**Tingewick Village Hall**

**Visual Inspection with Recommendations for Repairs  
with Proposals for a Full ongoing Maintenance Regime.**

December 1<sup>st</sup> 2010.

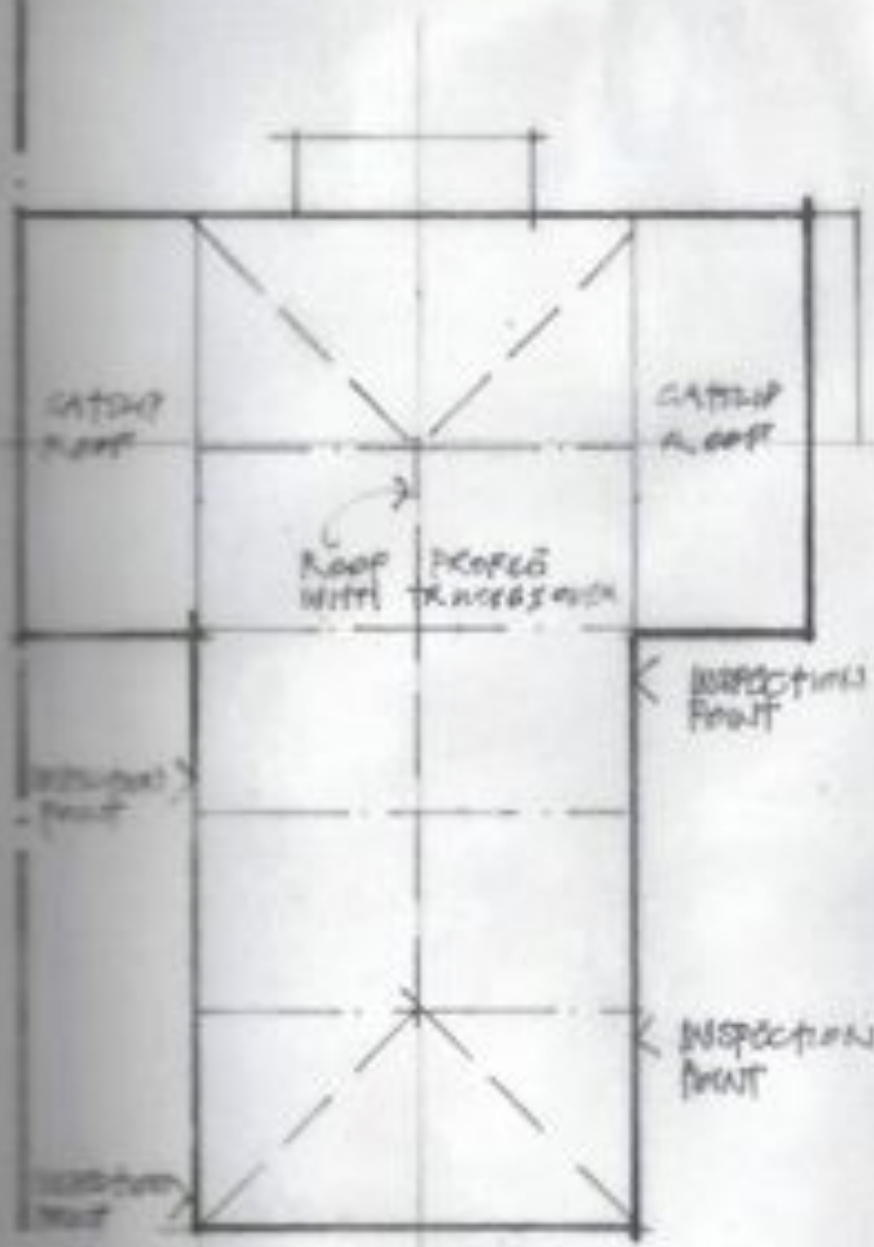
4 sections of boarding were removed for detailed inspection of the structure, these are noted on the enclosed sketch drawing.

The 2 separate positions of the removal along the west side clearly highlighted the results of the high ground levels adjacent. The panel immediately adjacent to the door

from the meeting room had rotted through and essentially fell apart during the extraction. The other although not quite as badly rotten will certainly end up in the same condition without some remedial action. Points along the East face revealed the structural post support for the roof trusses which although larger than the main framing is not in excess capacity. The small opening adjacent to the Female toilet revealed the inadequacy of the thermal insulation.

3.0. To commence programme of stripping off external boarding then to felt, insulate and reinstate damaged boards. I suggest 1 elevation per year minimum starting 2011. A detailed specification will be produced if this option is carried out, this to include internal insulation.	2011
Insulate roof up to the same standard as walls, ditto specification.	2011

4.0. To reduce the adjacent ground level along the external wall.	Immediately
5.0. Construct dwarf retaining wall 1m from the rear hall wall to create Path at correct level. In conjunction with item 5.0. above.	Immediately

LAYOUT AND DETAILS  
REPORTING INSPECTION REPORT

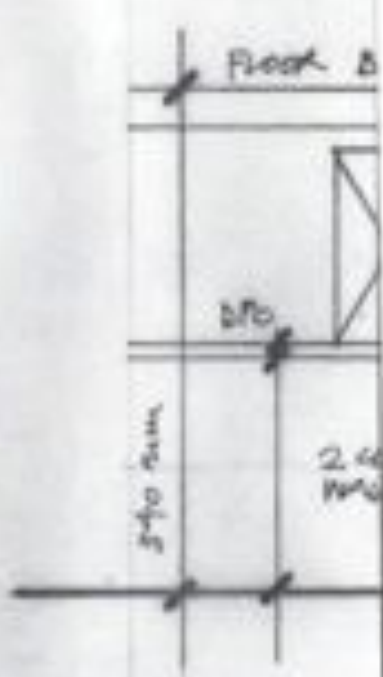
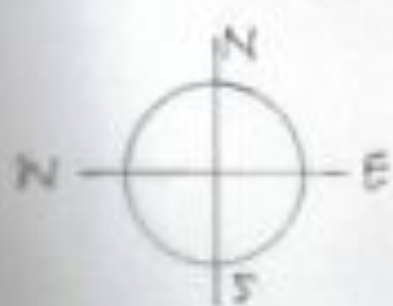
There is currently a problem of excessive bounce and knocking noises from certain sections of the floor when walking heavily across. The bounce to the floor is very distinct along the central line of sleeper walls within the hall and within the areas between the 2<sup>nd</sup> and 3<sup>rd</sup> trusses working from the kitchen end of the hall. When checked against a string line the depression within these areas was up to 10mm in depth.

In my opinion this problem could be caused by either;

- a. The new floor boards parting their connection from the joists

- b. The combined floor boards and joists parting from the connection onto the dpc running along the top of the sleeper wall, which may include any possible packers under the joists having dropped out.

If we now consider what the rectification options for both these items the easiest and possibly the cheapest initial solution to approach I would suggest would be carried out on option a. It would be relatively easy to screw and pellet along the line of the sleeper wall and reconnect the floor boards onto the joists below with minimum visual disturbance to the floor when sanded off. This first option which hopefully would reinstate a connection strong enough to bind the board and joist together would create an overall interconnected diaphragm bearing fully on the sleeper walls below.

Option b. If the option a above fails this becomes the next possibility to consider. It would involve a much larger area of the floor having to be lifted in order to open up the void and repack between the underside of the joists and the top of the sleeper walls. The area of disturbance would be within the middle section of the hall floor and connecting both areas of the bouncing problem. Visually the effects of the side and end saw cuts, which are necessary to cut through the tongue of the board, could be reduced by mixing the sawdust produced from the sawing with a bonding agent and scraping into the joints and sanding down.
